Reference: Re-submission of the ExxonMobil Canada Ltd. Eastern Newfoundland Offshore Drilling Program – Information Requirements – Additional Round 2

Additional Round 2 Information Requirements

**Flemish Pass Exploration Drilling Program
(CEAR 80129)**

**Eastern Newfoundland Offshore Exploration Drilling Project
(CEAR 80132)**

Figure 1 **EIS Figure 5-70: Ensemble Agreement of Project Near-Surface Ocean-Water Temperature Predictions**

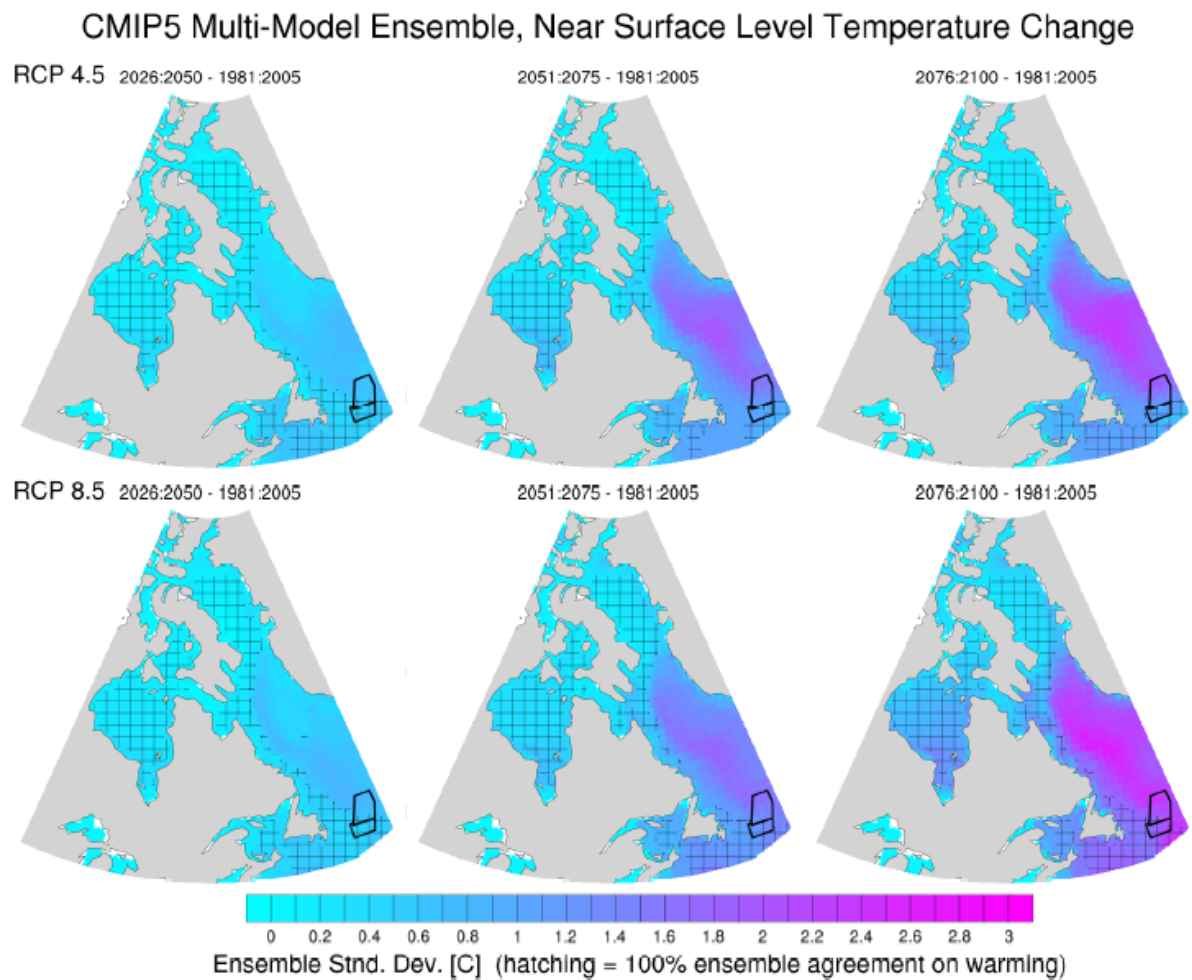
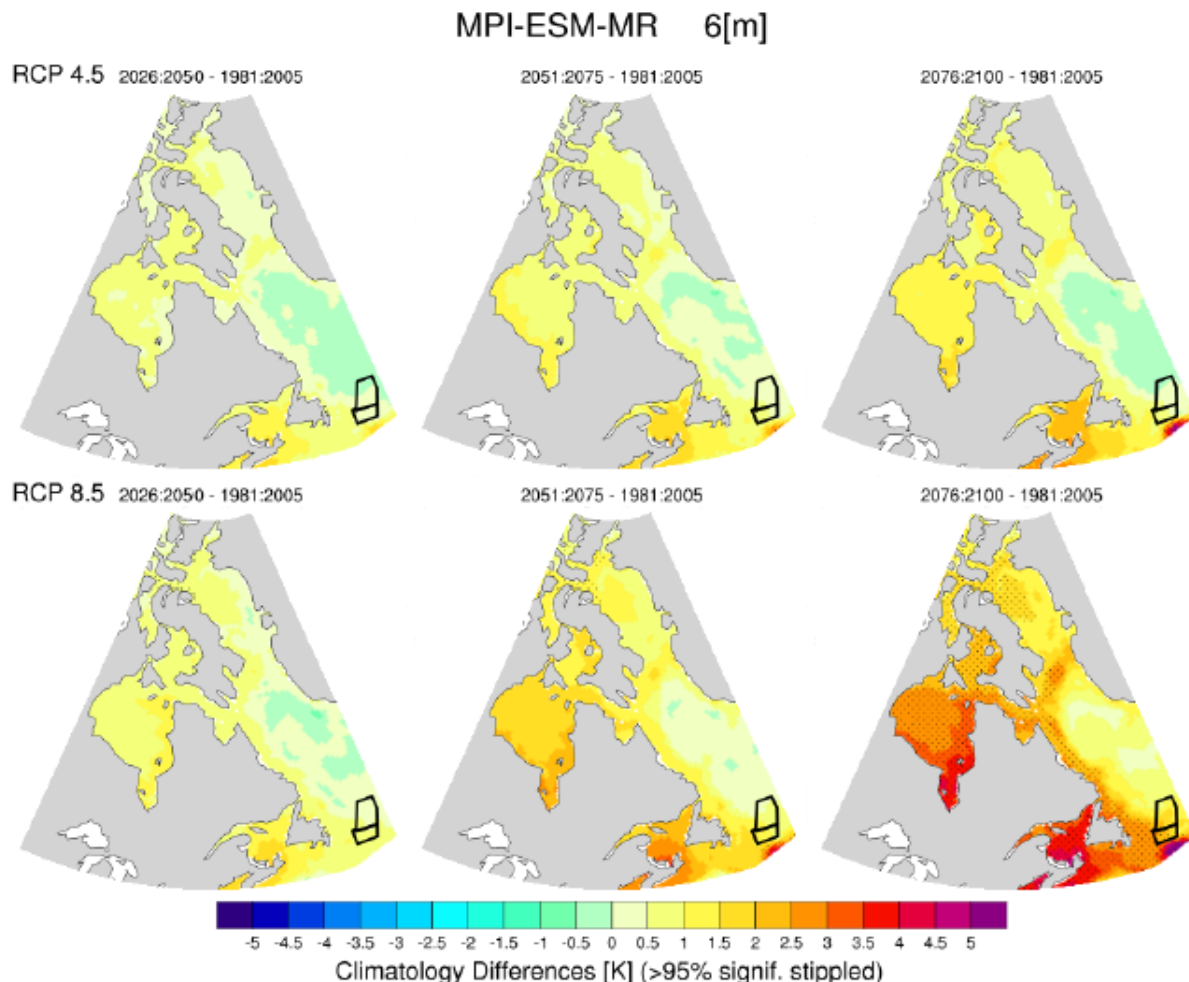
Provide clarification on contradictory information regarding sea-surface temperatures in the project area and the potential contribution this may make to current and future habitat use trends, taking into consideration the newly published research on sea-surface temperatures and Atlantic Salmon distribution.

Statistical summaries of sea temperature were derived for the same rectangular area surrounding the Project Area as that shown in Figures 5-70 and 5-71 of the EIS. Mean SSTs range from 1.6°C in March to 5.3°C in October. Minimum temperatures at the surface range from -1.8°C in January to 1.1°C in August and September. Maximum SSTs range from 4.0°C in March to 11.8°C in August. As shown, mean SSTs values greater than 3°C occur between July and November and the preferred range (4°C to 8°C) can occur between July and October. Minimum SSTs for every month are below 3°C.

As indicated, the mean predicted SSTs are below the preferred range (i.e., lower suitability) but above the temperature known to be physically avoided. Therefore, the statement within the original response to this IR remains unchanged; the limited interaction between salmon migrating within and near the Project Area and those post-smolt and adults feeding north in the Labrador Sea and kelts along the southern edge of the Grand Bank will most likely remain low given the predicted increases in SSTs (i.e., lower suitability) near the Project Area. As the potential for environmental effects of planned Project activities and overall risk to Atlantic salmon is low, it is not predicted that the Project will contribute to or exacerbate declines to salmon populations. As a result, the conclusion within the EIS based on existing data remains valid; the Project is not likely to result in significant adverse environmental effects on marine fish and fish habitat, including Atlantic salmon.

Figure 1 Other Projects, Including Proposed BdN Project, and Activities Considered in the Cumulative Effects Assessment (Including Distances from Project Area – Northern Section)

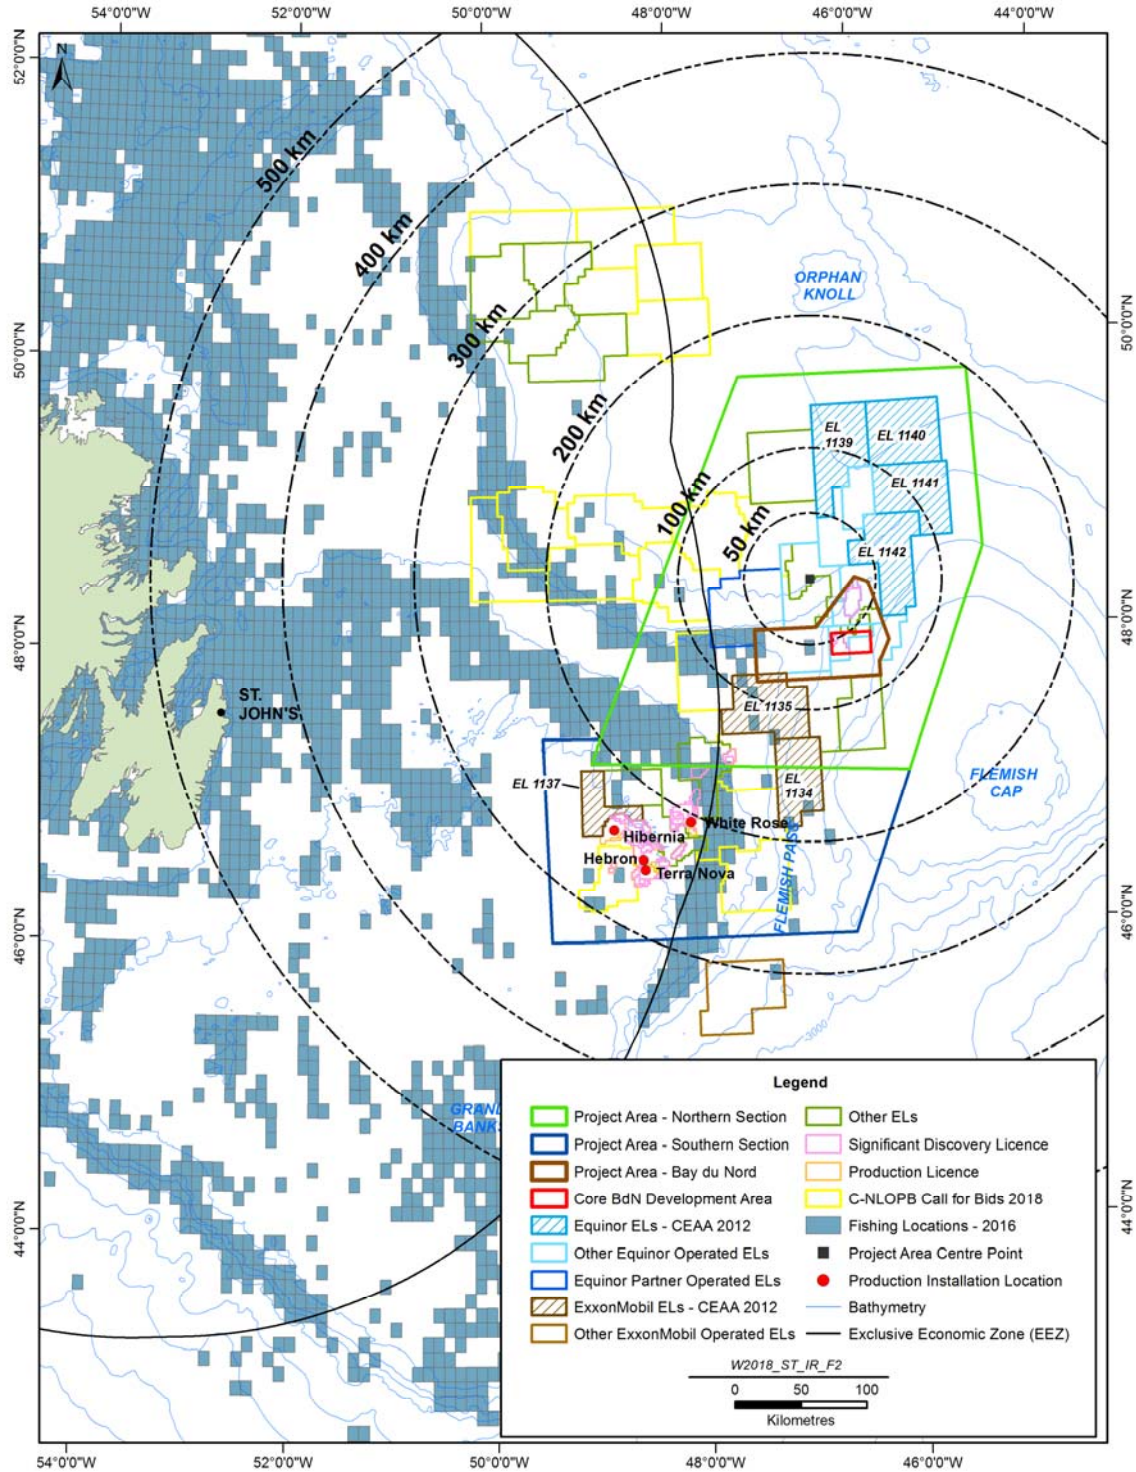
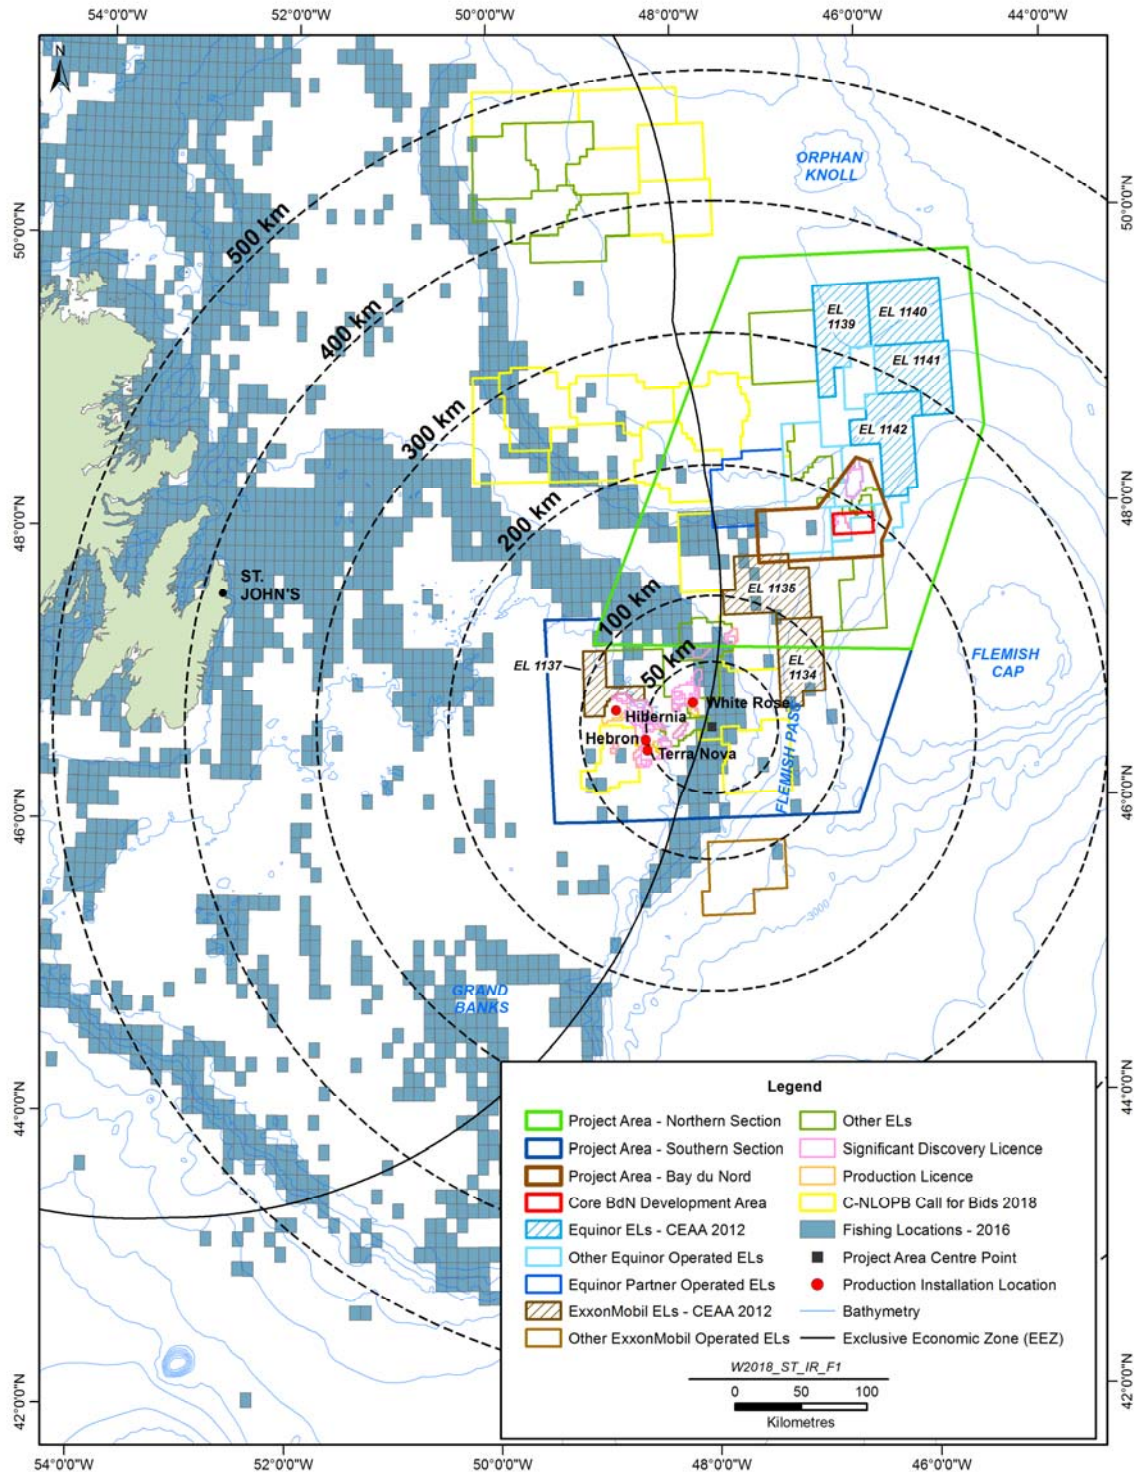
Since the EISs were prepared in 2017, additional, reasonably-foreseeable projects and activities have been proposed in the eastern Newfoundland offshore region, including Equinor's Bay du Nord Development Project. The analysis of cumulative effects provided in the EISs and in IR-86 requires updating taking into account new projects and activities.

Update the assessment of cumulative effects, taking into account taking into account projects and activities that have been proposed since the EISs were prepared.

An overview of the proposed BdN project is outlined in Table 1 below. Figures 1 and 2 (updates to EIS Figures 14-1 and 14-2) have been updated to include the location of the proposed BdN project. The Operators have also taken the opportunity to incorporate general updates to Figures 1 and 2 (e.g. fishing locations, call for bids).
